SERVICE BULLETIN

APPLICABILITY: 2019MY Forester

NUMBER: 12-262-19

SUBJECT: Hood Release Cable -Design Change

- Comparison Illustrations between the New and Old-Style cables:

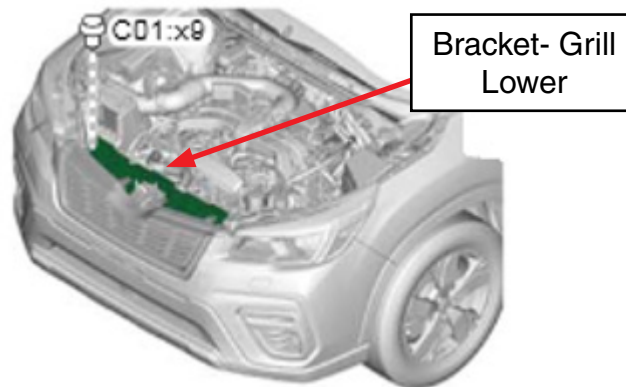
This bulletin announces availability of a new hood lock release cable to address concerns of the front hood lock not releasing when the release lever is pulled. The new inner cable diameter has been increased and the shape of the cable end has been changed to improve engagement between the release cable end and the lock release mechanism. Latching of the hood is not affected by this change.

The part number for the new style CABLE-FRONT HOOD is **57330SJ011**.

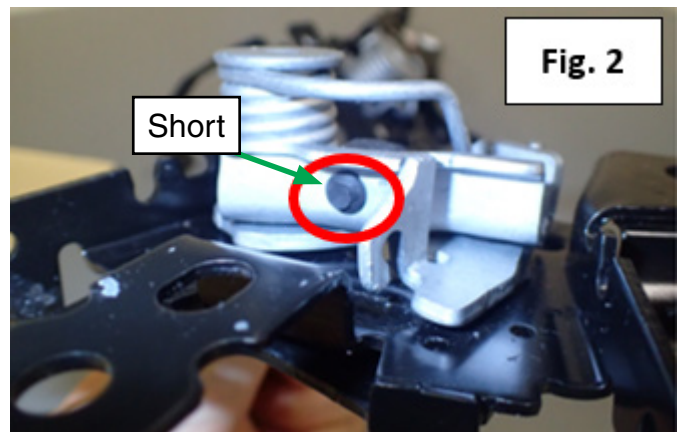
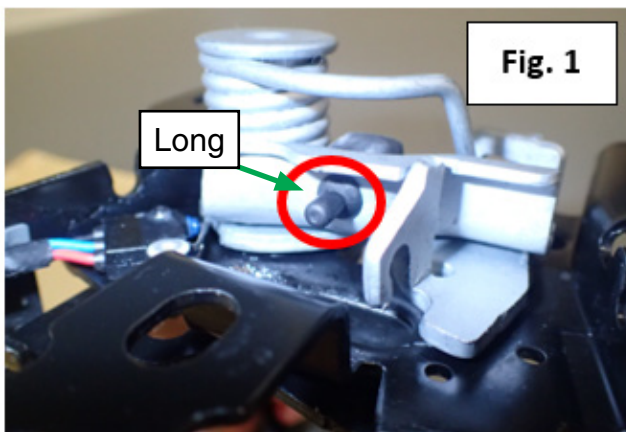
Step 2) Inspect the hood lock closely for the rubber buffer shown in the photos below. Fig. 1 shows a buffer with a long projection while the buffer's projection shown in Fig. 2 is very short.

- If inspection reveals a hood lock with a “long” projection buffer as shown in Fig. 1 above, 4mm from the end of the projection must be trimmed off using a small wire cutter or equivalent. Use the illustration below as a guideline.

- If the buffer has a short projection as shown in Fig. 2 above, proceed to Step 4.
